A NEW PROCESSING SYSTEM FOR THE PRODUCTION OF IMPROVED REFUSE DERIVED FUEL AND RECYCLABLES FROM MUNICIPAL SOLID WASTE

MICHAEL H. ELEY AND GERALD R. GUINN

Discussion by:

The following are the questions and comments on the paper.

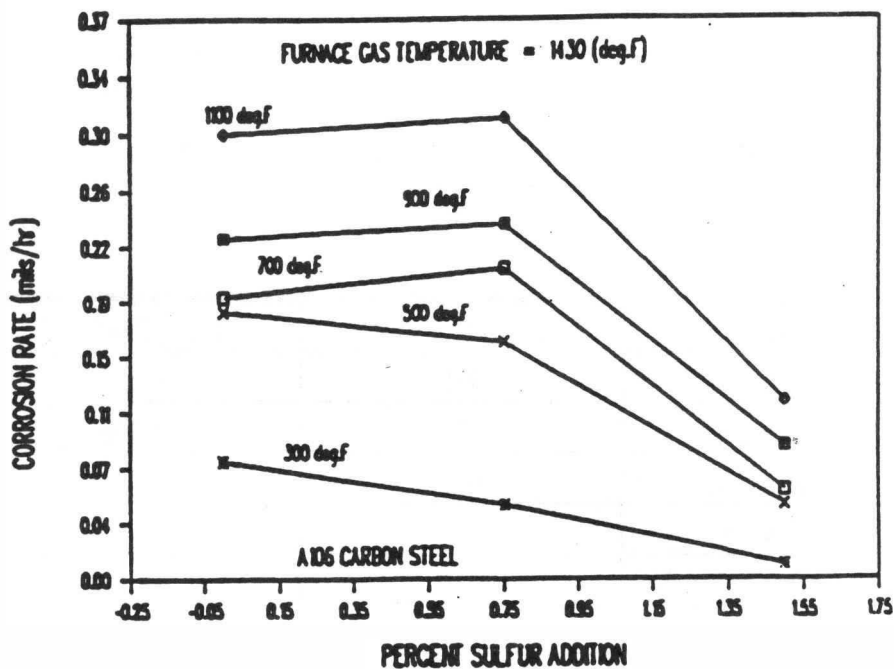
(j) On p. 289, the first two Ref. [9] conclusions need further explanation. The first conclusion implies that if the sulfates were not present, the chlorides would not be converted to hydrochloric acid. The second conclusion conflicts with the first, stating that sulfur should be added.

(k) The third conclusion on p. 289 states that corrosion will not increase when co-firing RDF with coal. It does not conclude that corrosion is reduced, yet on the same page it states that chloride corrosion is reduced significantly, implying that overall corrosion is reduced.

(j) The three conclusions regarding chloride corrosion were obtained from Ref. [9], and attempts to resolve the contradiction were not entirely successful. Reference [9] had referenced "an extensive study ..." of chloride corrosion of both RDF and MSW cofired with high sulfur coal (Vaughan, D. A., Krause, H. H., and Boyd, W. K., "Chloride Corrosion and Its Inhibition in Refuse Firing," *Proceedings of the International Conference on Ash Deposits and Corrosion from Impurities in Combustion Gases*, New England

College, Henniker, New Hampshire, June 26–July 1, 1977, The American Society of Mechanical Engineers, pp. 473–493). A copy of this paper could not be obtained to determine if the first inclusion was mis-worded from that original source. A chemist asked to review the statement could not establish the reactions implied to in the first conclusion.

The second and third conclusion are based on experimental data provided by Ref. [9] from the original source. These data showed significantly decreased corrosion rate (0.30 mils/hr to 0.10 at 1100°F) as the percent sulfur increased from 0 to 1.55. This figure is presented below to illustrate the effects of sulfur content corrosion rates at other gas temperature.
